PROJECT INFORMATION

site address	3405/3411/3417 Harbor Ave SW
parcel numbers	7987400130, 7987400140, 7987400150
project number	3034147-EG

Scheme 3: INTERLOCK (PREFERRED)

massing @ EDG

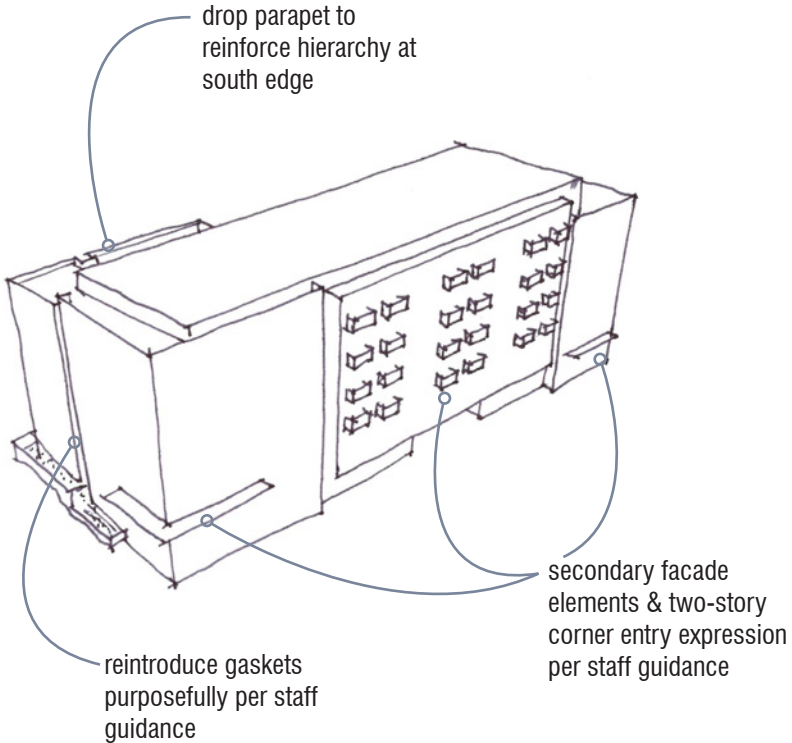
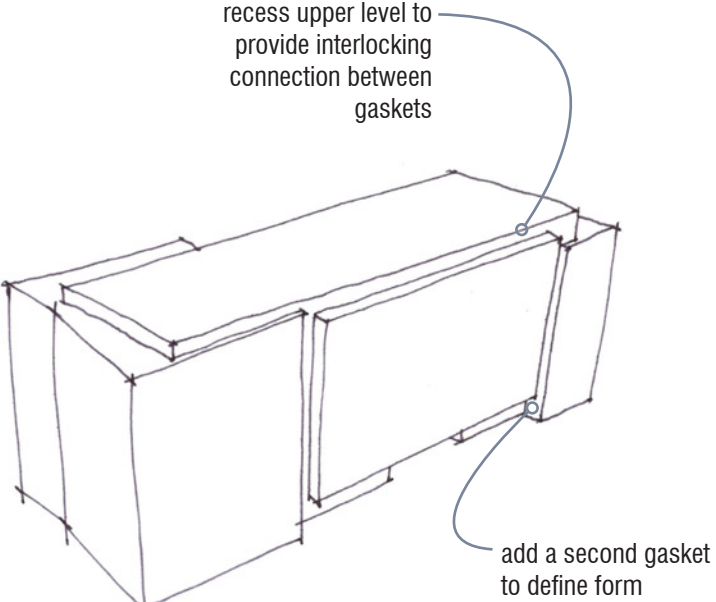
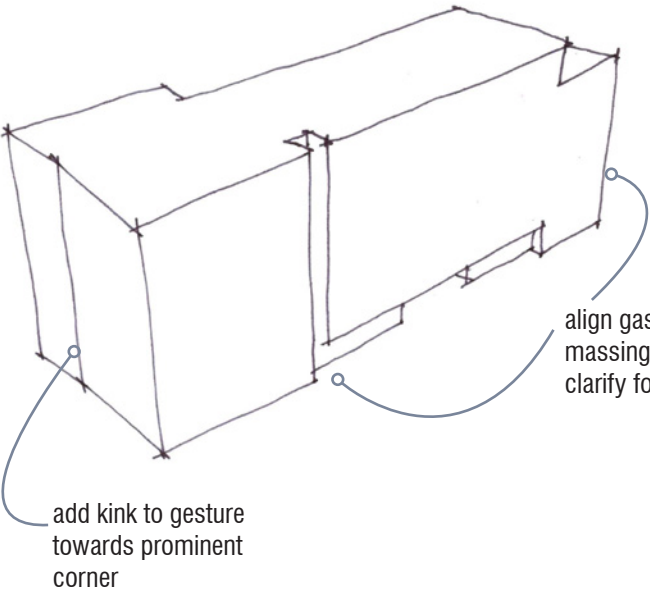
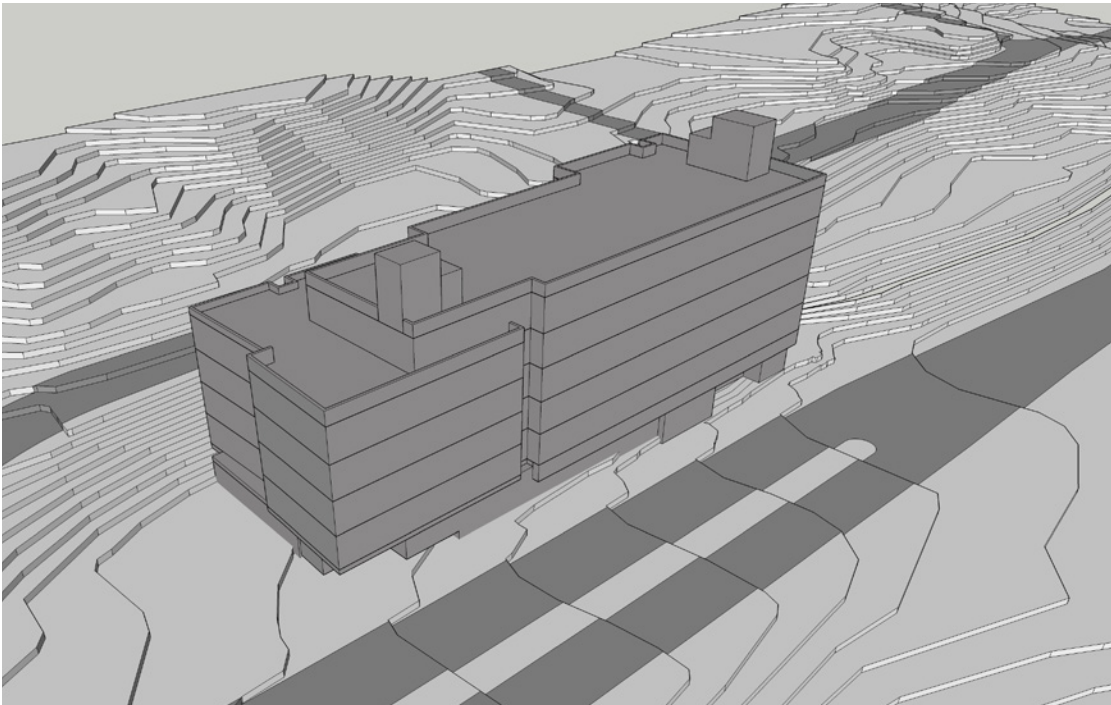
Southeast Corner - The Board was supportive of the beginnings of the southeast corner expression but would like to see the corner be treated as more of a gateway with greater presence through material detailing and perhaps massing refinements. The Board suggested simplifying the massing from a split form to a singular massing volume on the south façade (CS2-A, CS2-D).

Following the Board’s guidance, the design team explored a refined and simplified overall massing, particularly at the southwest corner expression. Rather than maintaining a dropped massing at this southwest corner per the EDG proposal, the corner element has been extended vertically by extending to the 5th floor, and continuing the mass down to the grade plane. The modulation of the split form has been simplified, initially with a singular massing volume. Per staff guidance, subsequent development of the massing has reintroduced the gaskets at the south and west facades, but maintains the taller, clarified massing. Larger glazing panels in an expressive pattern, wood accents, and a simple siding pattern (related to, but not identical to the rest of the mass) strengthens the south corner and gateway expression.

- The taller, unified massing expression at the south corner helps to signify its prominence as the main entry and a gateway expression.
- The mass is extended to the grade plane in order to help ground the mass.
- A large feature awning has been added to reinforce the corner expression.
- The massing’s kink (amplified by the gasket) gestures towards the corner, allowing the materiality of the corner to be expressed differently than the rest of the mass.
- Windows and doors throughout the façade are stacked vertically, with the exception of the southeast corner. The staggered windows allow for the incorporation of wood panels related to, but distinct from the rest of the building. This distinct compositional order reinforces the corner element.

view of south lobby

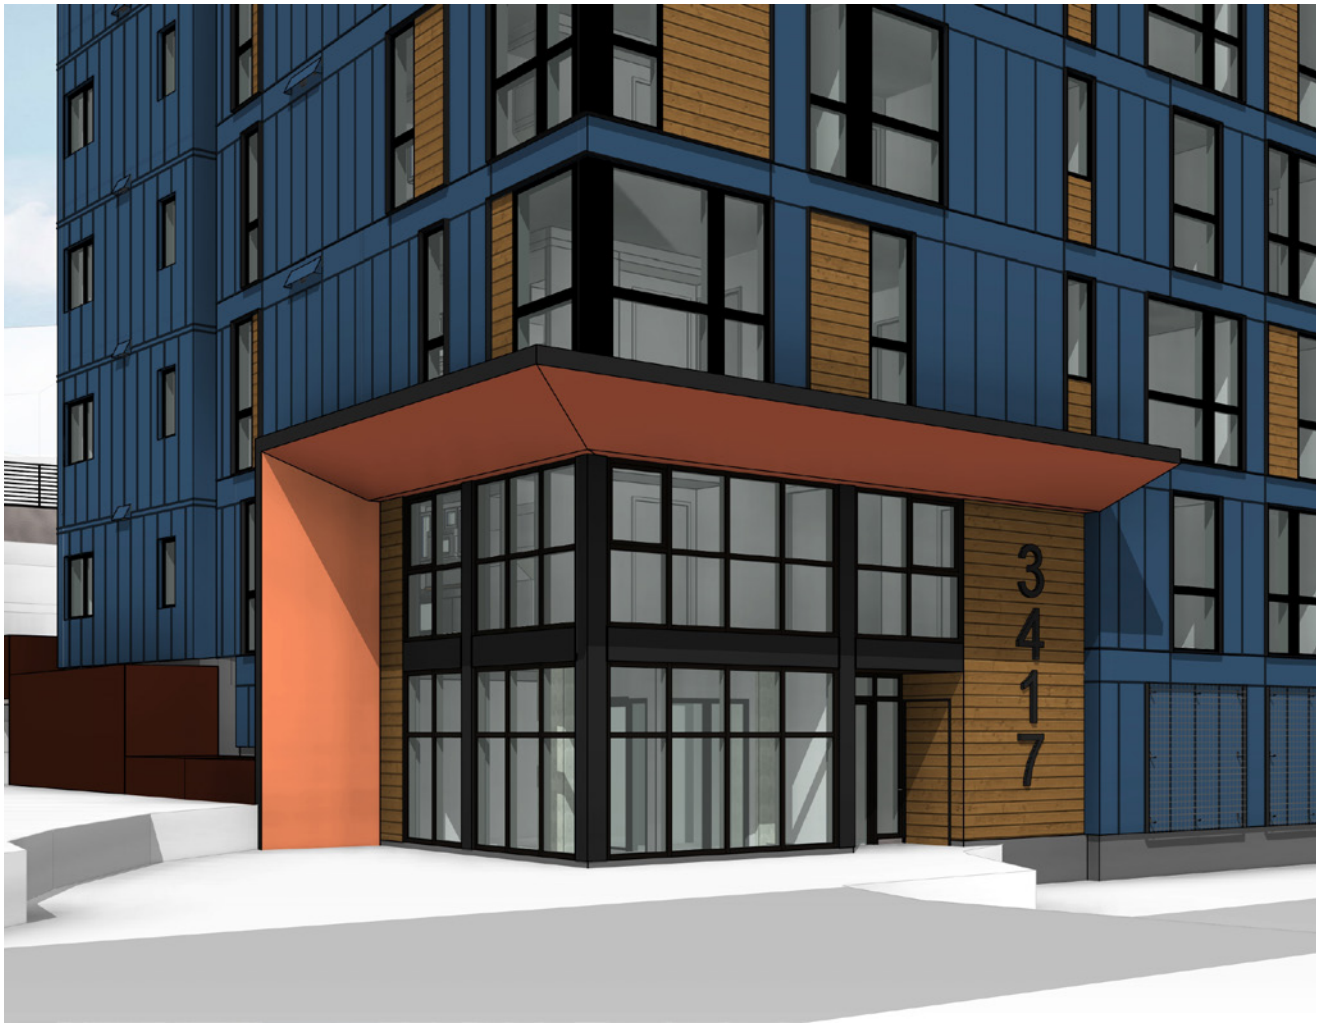
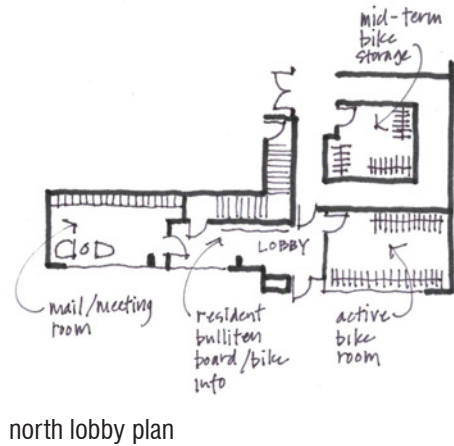
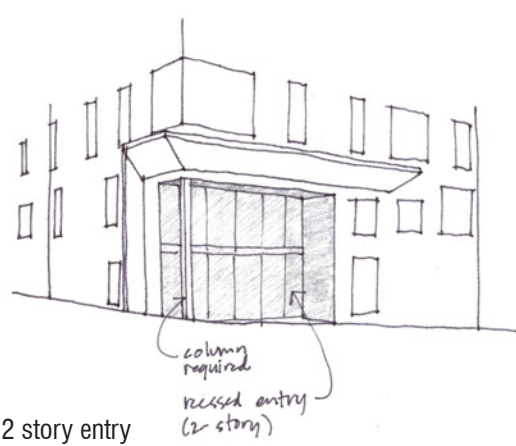
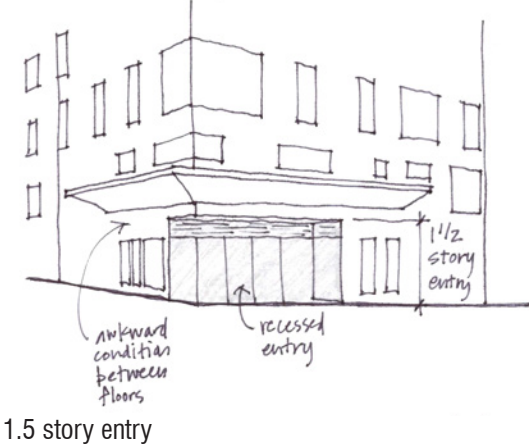
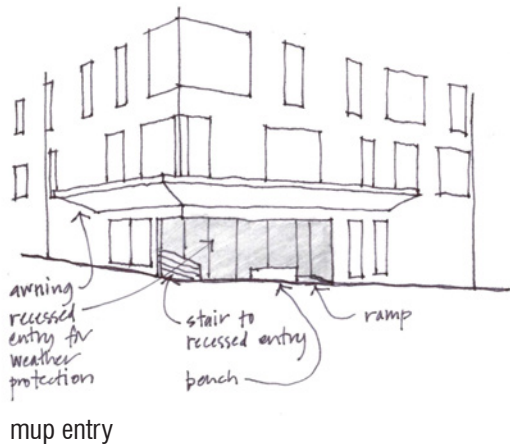
Harbor Ave - Related to the corner expression, the Board provided guidance to enhance the expression of the lobby entrance at the southeast corner exploring greater height, size, seating, lighting or other means of enhancing legibility of the entrance. In addition, the Board would like to see the north end exit along Harbor Avenue become a secondary lobby rather than an egress only (CS2-B2, PL3-A).

Previously, the proposal included a recessed residential entry at the southeast corner, with an exit-only condition at the northeast. The plan has been reworked in order to accommodate a primary entry at the southeast corner and secondary entry at the northeast corner. These entries relate to each other visually, but prominence is given to the southeast entry (as the corner expression) through massing and detailing. The scale, detailing, and proximity to the bus stop of the southeast entry identifies it to visitors as the main public entry, while the northeast entry has been modified and enlarged to function primarily as a resident entry.

The design as proposed at MUP included a sunken entry and a pitched awning at the southeast entry in order to provide additional height. Staff guidance suggested that this created a pinched condition rather than a grandeur entry expression and requested that we evaluate a two-story option. Following that guidance, we evaluated several options including a 1.5 story entry and 2 story entry. However, due to the small unit size above the lobby and the compact lobby itself, this resulted in an awkwardly tall lobby experience while also resulting in the loss of a unit. Focusing on the staff guidance to provide a grandeur entry expression, we have raised the awning, enlarged the lobby to align with the floor above, and treated the fenestration of the unit above in the same manner as the lobby. This design allows for a two-story expression commiserate with the scale of the building

- The taller southern massing, with the larger corner awning, storefront glazing, and wood siding immediately identifies itself as the public entrance.
- The awning at the southern massing angles upwards in order to enhance the height and volume of the entry sequence, again signifying it as the main entry.
- The awning at the northern entry reflects the same material palette, in a more modest scale, prioritizing function.
- Exterior signage and lighting have been provided at both entries, with a priority in size given to the southeast entry.

proposed east (harbor ave sw) elevation

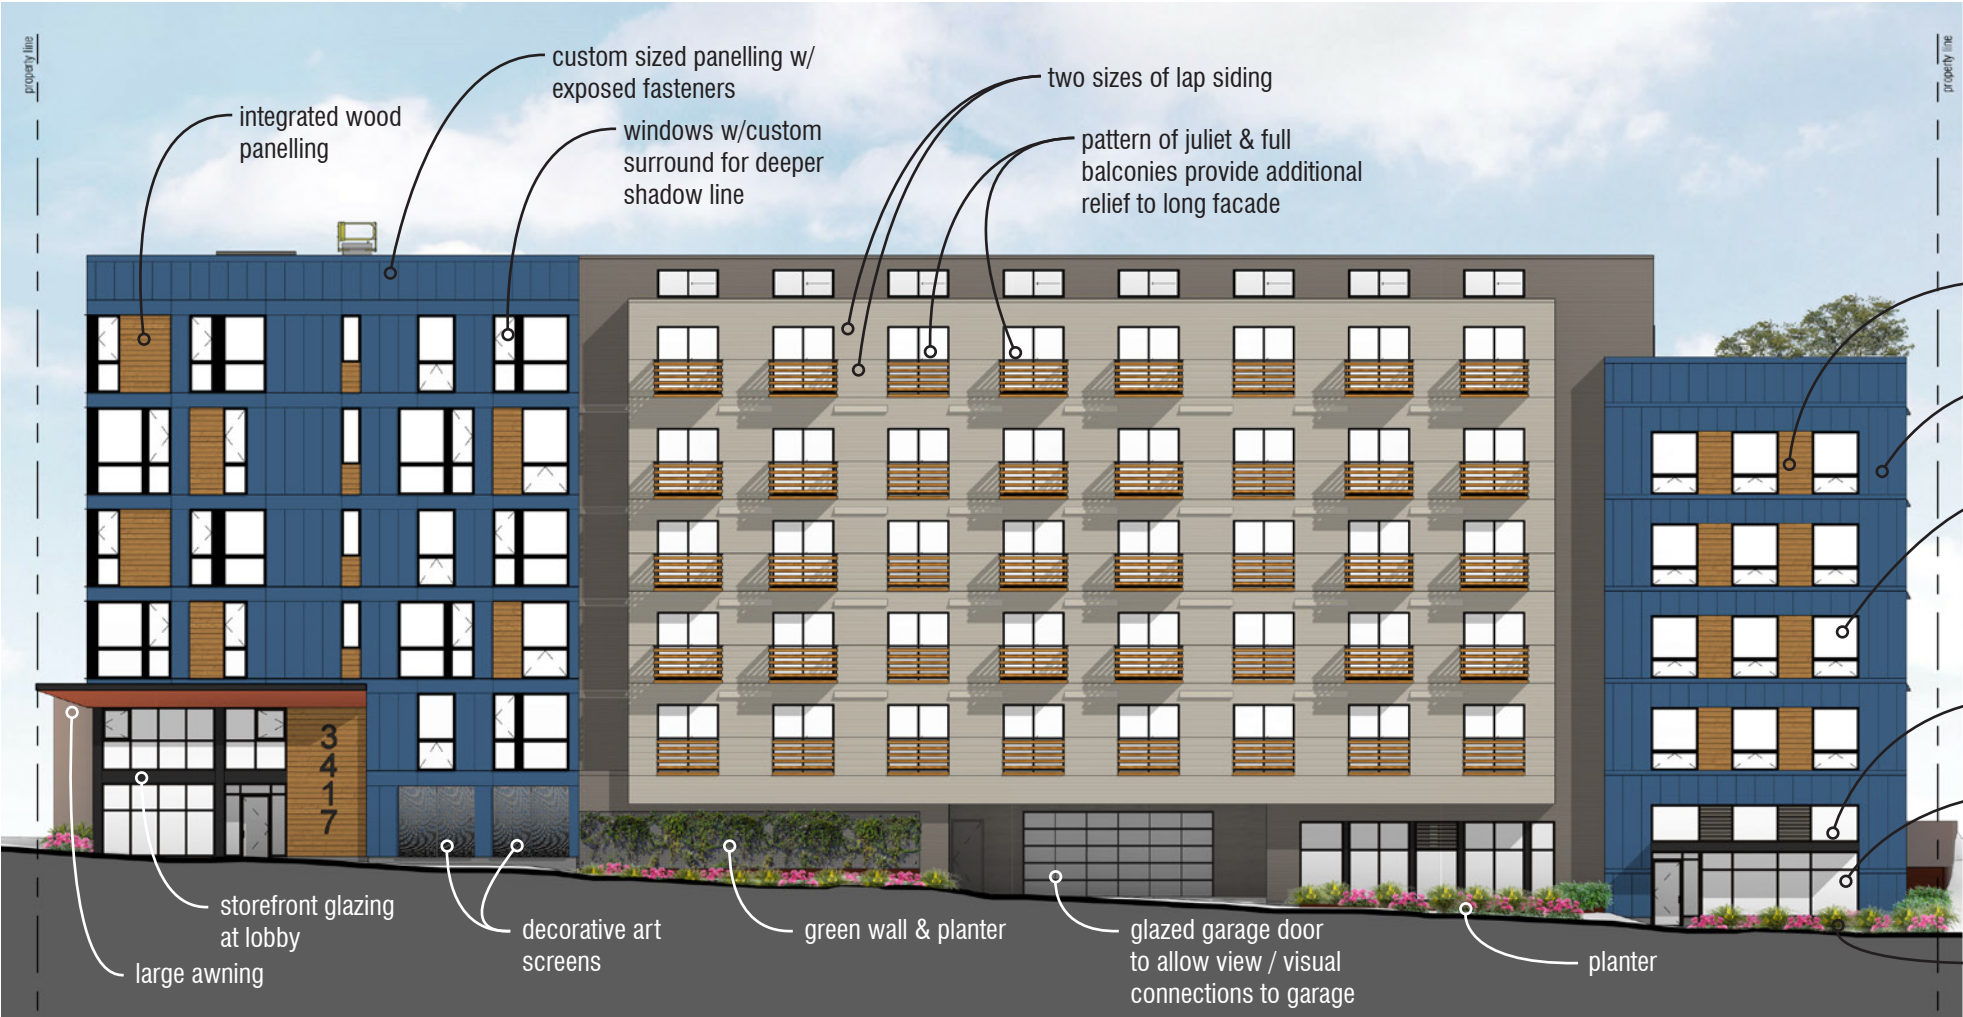
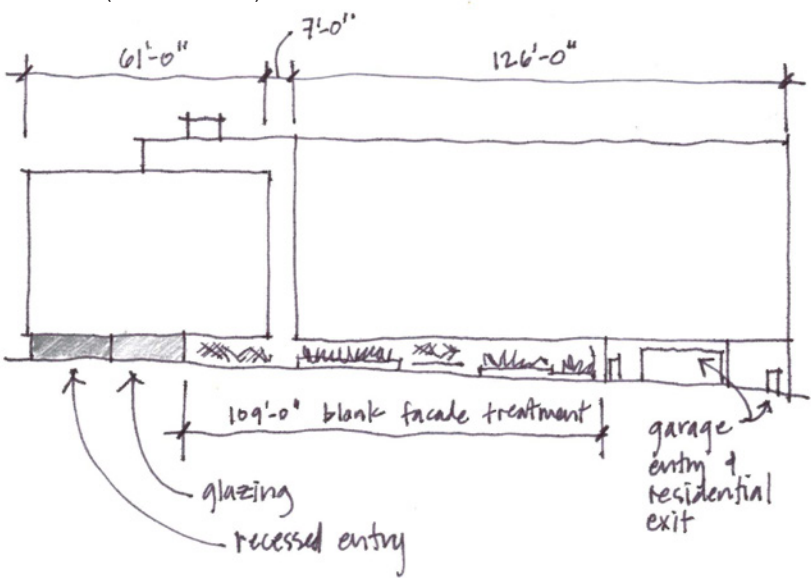
Harbor Ave - The Board was concerned with the 126' façade length along Harbor Avenue. At the next meeting the Board expects to see material application and secondary detailing to break up and provide a smaller scale to this long street frontage (CS2-D, DC2-A, DC2-B1)

In response to the Board's guidance regarding the massing of the southeast corner expression, stepping down the massing at the north edge, and providing a secondary northeast entry, the massing has now been broken into three, with the northern and southern nodes connected by a central interlocking bar. Additionally, gaskets have been provided, separating each mass, which aids in further breaking up the overall length of the façade. The addition of balconies and julets as secondary elements at the center mass help to further break down the length of the façade. At the ground level, programmatic elements have been rearranged to accommodate additional glazing and visual interest.

- The proposal seeks to use different siding and fenestration languages to create visual interest and movement along the street frontage; the north node uses a lively siding pattern with regimented windows, while the southeast corner expression uses a regimented siding pattern with lively fenestration and wood paneling. The central interlocking bar utilizes a connective horizontal banding pattern for the floors above, and horizontal board formed concrete for the garage level.

- On the upper floors, siding type and detailing such as recessed windows and doors on the north and south nodes bookend the structure. Secondary detailing is provided with balconies and julets.

- The section of wall without fenestration has been significantly reduced from the EDG proposal. Greenscreens and planters are provided along this section, which will help break up the façade length while contextually responding to similar planters in the neighborhood.

The east elevation (harbor ave) at EDG had long sections of facade, up to 126'. The revised design breaks the facade down into smaller sections and also provides additional secondary detailing to provide a smaller scale to this long facade.

option 3 (proposed):

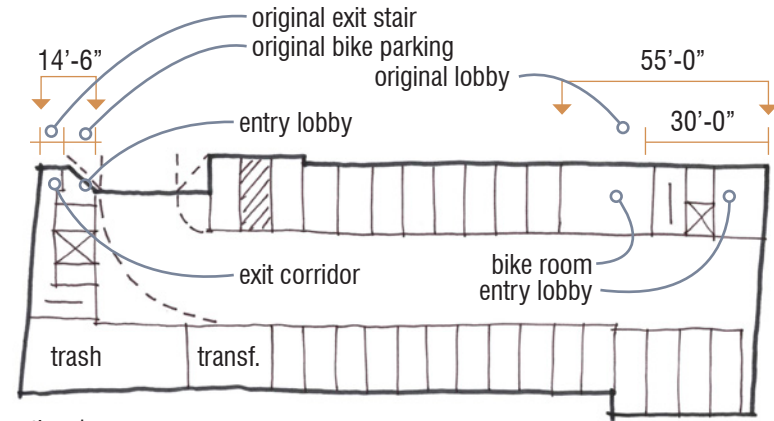
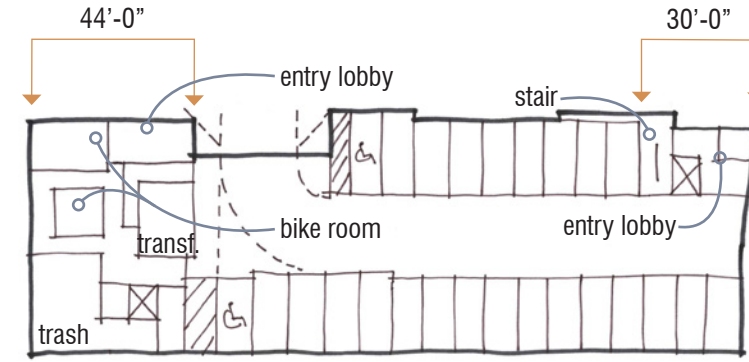
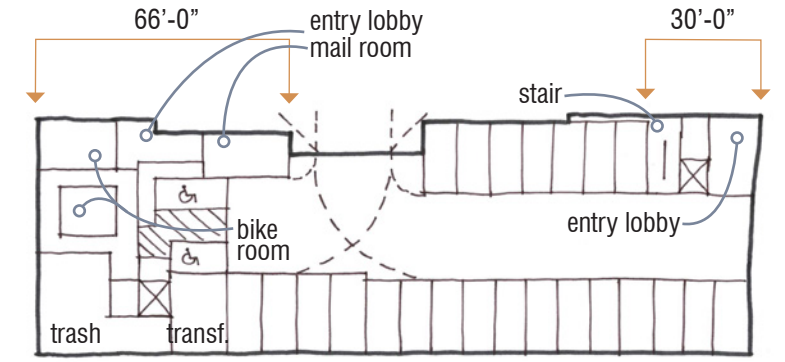
Harbor Ave - The Board was concerned with blank wall along the parking garage level and provided guidance to further explore alternative layouts of the floor plan with the goal of improving visual interest and activation along the street-level. The Board suggested swapping out the bicycle storage and parking spaces (DC2-B2, DC1-C2).

Per the Board's guidance, we evaluated several new parking layouts that would accommodate reduced parking fronting the street façade. In particular, it was suggested that we flip some of the car parking and bike parking, so that there could be a more active front façade. We evaluated several different options for the parking layout, and ultimately revised the plan in response to the Board's guidance.

- The blank wall directly in front of the parking is mitigated with the addition of planters and green screens.
- The section of wall without fenestration has been significantly reduced from the EDG proposal. Greenscreens, planters, and an art screen incorporating signage are provided along this section, which will help break up the façade length while contextually responding to similar planters in the neighborhood.

- In an effort to provide even more transparency, the garage door (which will remain mainly closed) will be open grate for transparency. Additional safety features at the garage entry/exit include full sight triangles (no request for reduction) and patterned/grooved pavement at the garage entrance to alert pedestrians of this access point.

terraced landscape

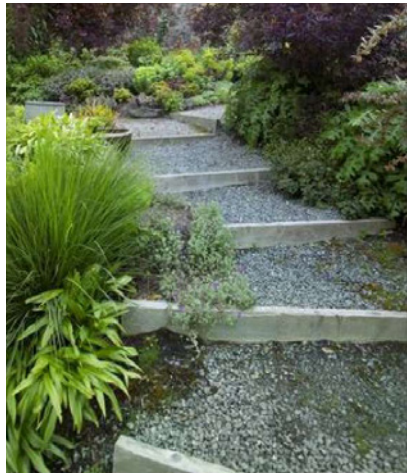
30th Ave SW - Along 30th Avenue SW the Board would like to see further refinement that creates a more neighborly response, perhaps creating a connection to the courtyard or common residential entry, terracing slope down to the courtyard and patios, and clarifying both the landscaping and fall protection along this edge (DC2-A1, CS1-C).

- In coordination with SDOT, the sidewalk will be provided on the west side of the street, in order to connect safely to the greater sidewalk network. The street will also be widened in an effort to better support the existing neighborhood, as well as provide safe transit for fire and medical vehicles. The west side of the street will have a curb, and where required a retaining wall with safety guard along the edge of the slope.

- The landscape design along 30th Ave employs a variety of pre-cast concrete sculptural landscape elements which help to terrace the landscape and provide benches and steps in order to activate the courtyard and visually connect it to 30th Ave.

- The landscape design along this façade continues to develop the layering concept proposed at EDG, softening the hillside with layers of planting, adding texture and color for both the building’s residents and neighbors to enjoy. Bioretention planters double as retaining walls in order to help provide softer grade transitions.

- Several of the 1st floor units have access to patios, and the majority of the upper level units have balconies which help to activate the façade and provide a direct visual connection to 30th Ave.

- A residential entry has been added to the northwest node as recommended by the board. A stair and associated bike runnel have been provided in order to allow residents a neighborly, and easy access to 30th and beyond.
